## Application for Works Approval

**Works Approval Number** W6558/2021/1

**Applicant** Doral Mineral Sands Pty Ltd

**Premises** Yalyalup Mineral Sands Mine  
South of Princefield Road;  
West of Ludlow-Hithergeen Road;  
North of Yalyalup road; and  
East of Wonnerup South Road  
YALYALUP WA  
Legal description -  
Tenement M70/1400

**Figure 2: Distance to sensitive receptors. Note that houses labelled with an R are receptors considered in the noise modelling.**

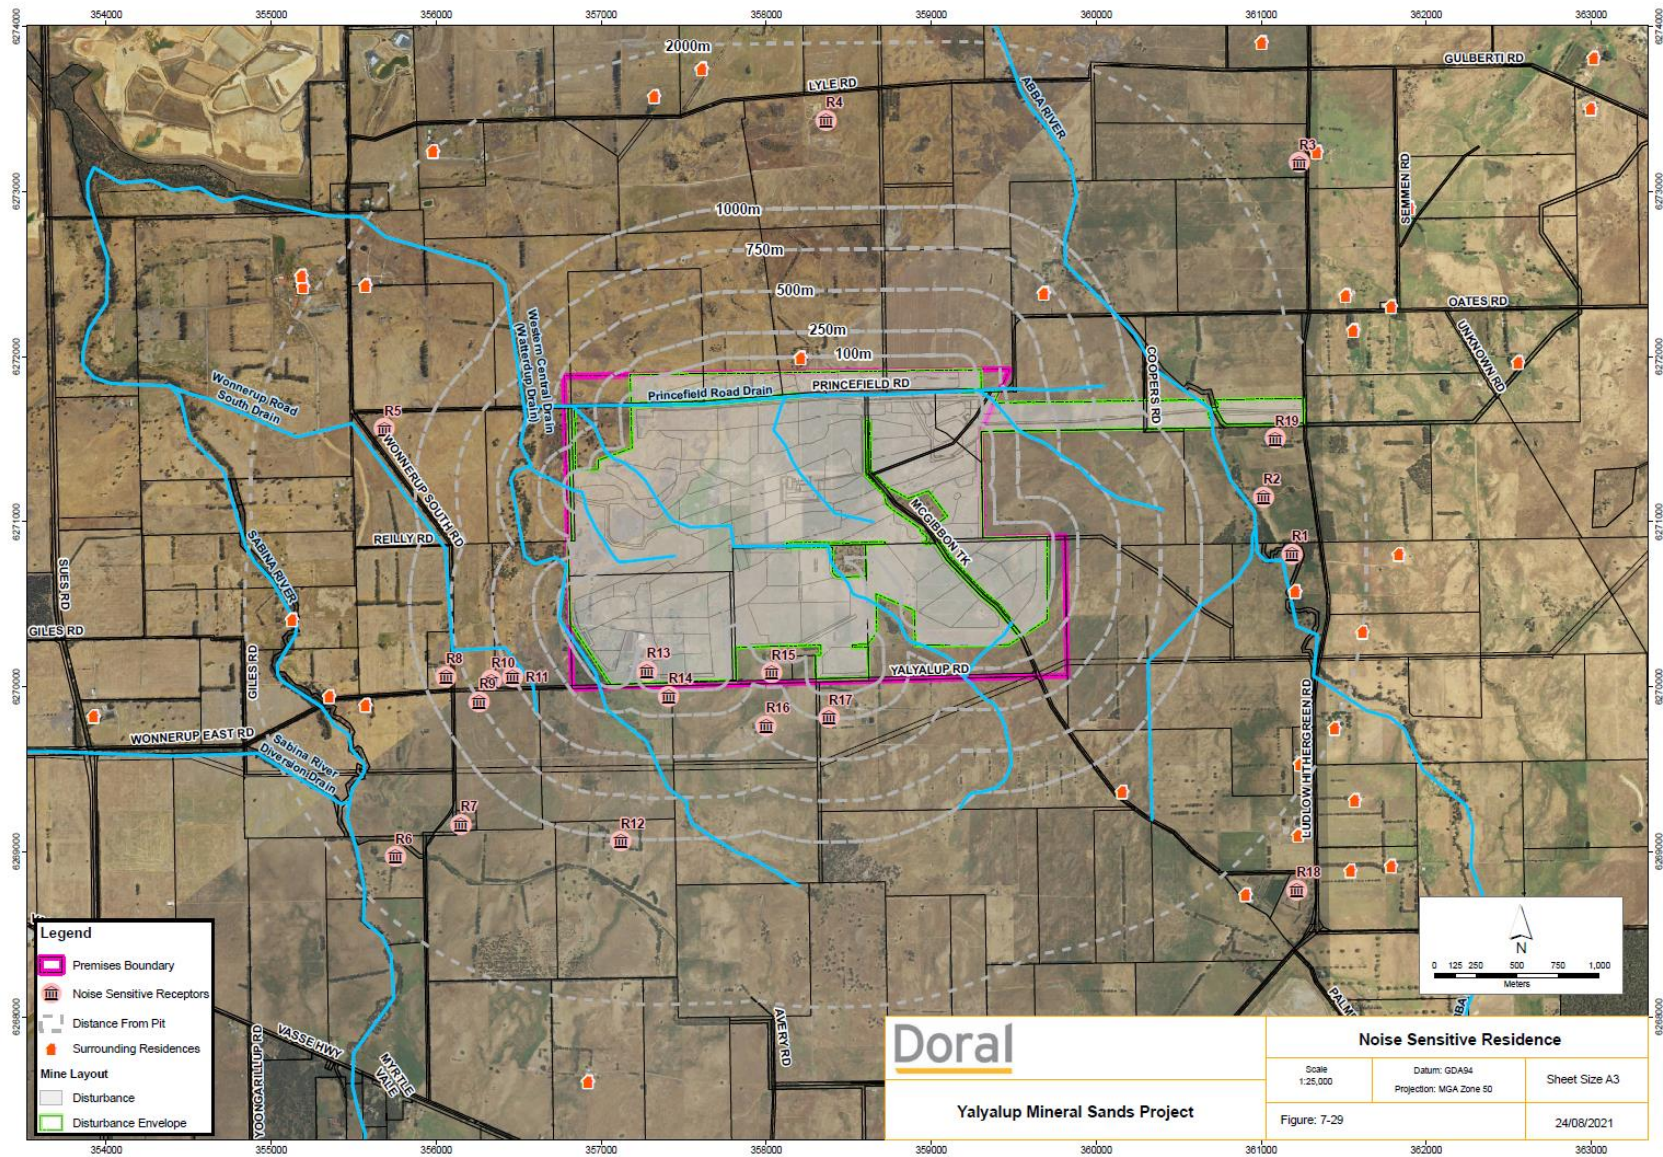
Table 2 and Figure 2 below provide a summary of potential human and environmental receptors that may be impacted as a result of activities upon or emission and discharges from the prescribed premises (*Guideline: Environmental Siting* (DWER 2020)).

**Figure 5: Assumed noise source locations for scenario 6 – Day mining February 2024**

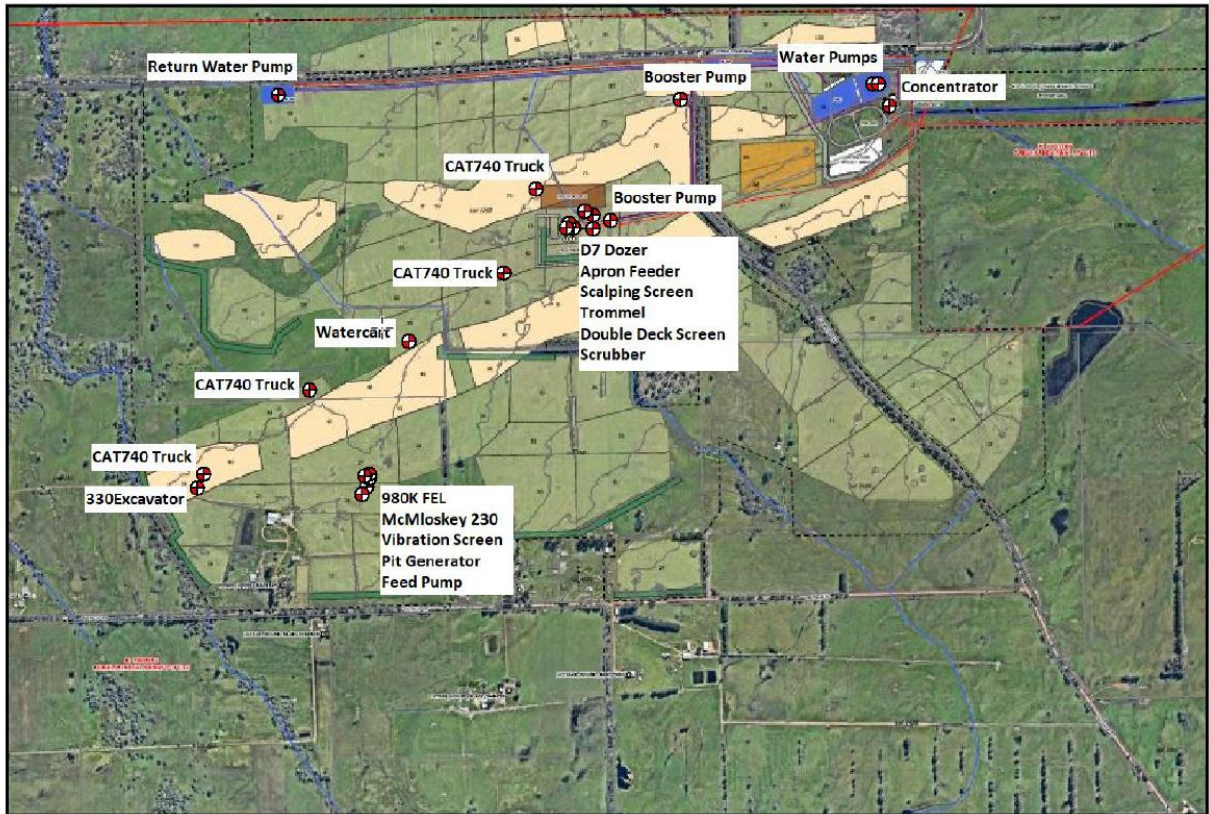
Figure 4 shows modelled potential exceedances of the assigned noise levels, with various wind directions for the various mining stages. The greatest impact is likely to be in scenario 6, when mining is occurring in the southwest corner closest to receptors (Figure 5). The Delegated Officer notes that the modelled scenario closest to the receptors to the south does not assume any machinery right on the southern boundary, but approximately 250m north (Figure 5). The applicant has committed to not mining within 300m of a residence occupied by a member of the public (excepting employees or contractors of the applicant) unless there is an amenity agreement in place. Amenity agreements are in place for receptors R8, R9, R10 and R11. An agreement has been drafted with the owner of R14, R16 and R17, which is awaiting signing. No agreement has yet been reached with the owner of R13 and R15.

The Delated Officer notes that the Noise Regulations apply to mining operations. Monitoring is required to both inform operational decisions regarding noise, and measure compliance with these regulations. The proposed monitoring is assessed in section 3.3.1.

The Delegated Officer considers that given the management measures in place to prevent noise impacts, it is **Possible** that there may be a low-level impact to amenity resulting in a consequence rating of **Minor**. The Risk rating is therefore **Medium**. It is noted however that many of the controls proposed are critical in minimising the risk and therefore the applicants proposed controls will be placed as conditions on the works approval.

**Figure 7: Local surface water flow and existing surface water monitoring points**

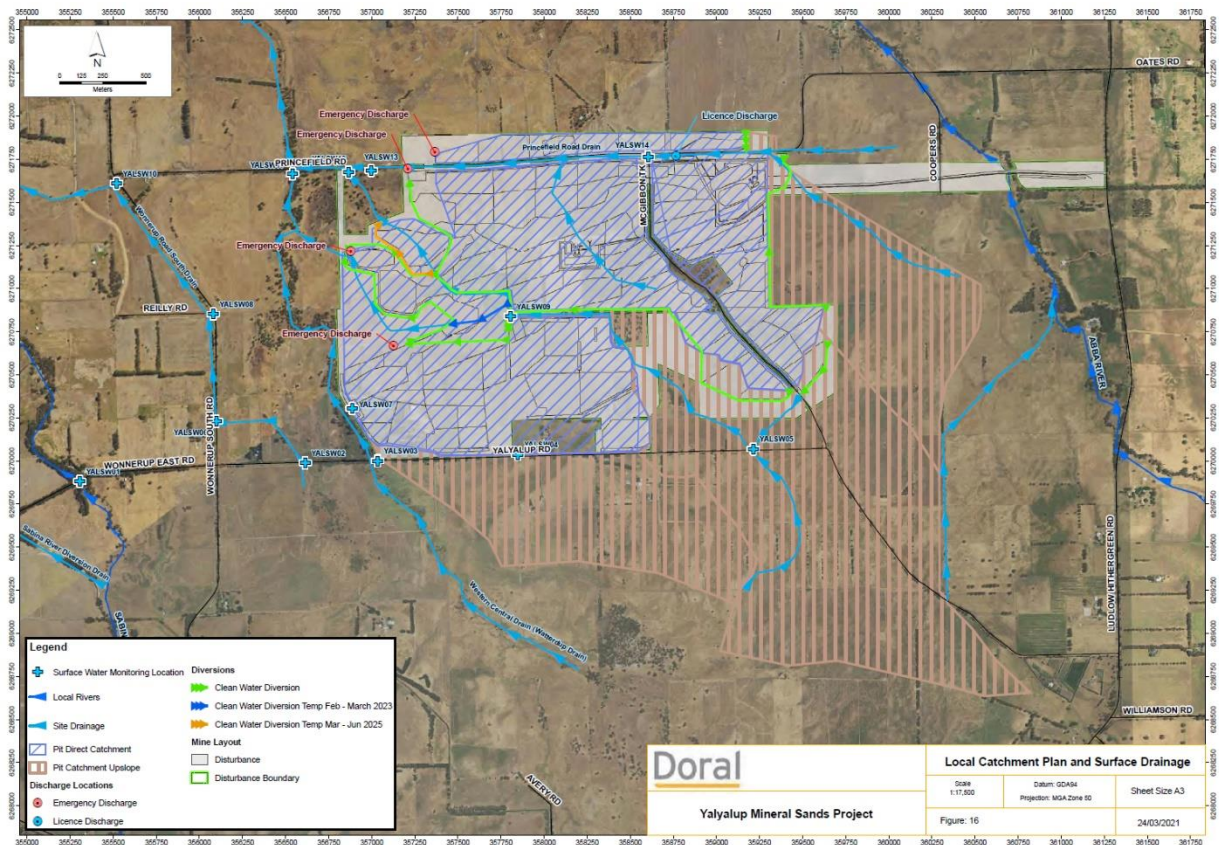
The applicant has been undertaking surface water monitoring at surface water monitoring points denoted YALSW01 to YALSW14. These are shown in Figure 7. This suite of data is valuable for ongoing management of surface water throughout the operation. For the purposes of this works approval, the Delegated Officer considers that the critical points for monitoring environmental impact are upstream of the licence discharge point and mining/tails deposition areas, and downstream of these. YALSW03 and YALSW05 are suitable upstream points. As there is no existing monitoring point upstream of the licence discharge point to provide background water quality, the Delegated Officer will require a new monitoring point YALSW15 upstream of the licence discharge point. YALSW11, YALSW12 and YALSW13 are suitable downstream monitoring points. Parameters and limits will be set for consistency with similar operations with similar receptors.
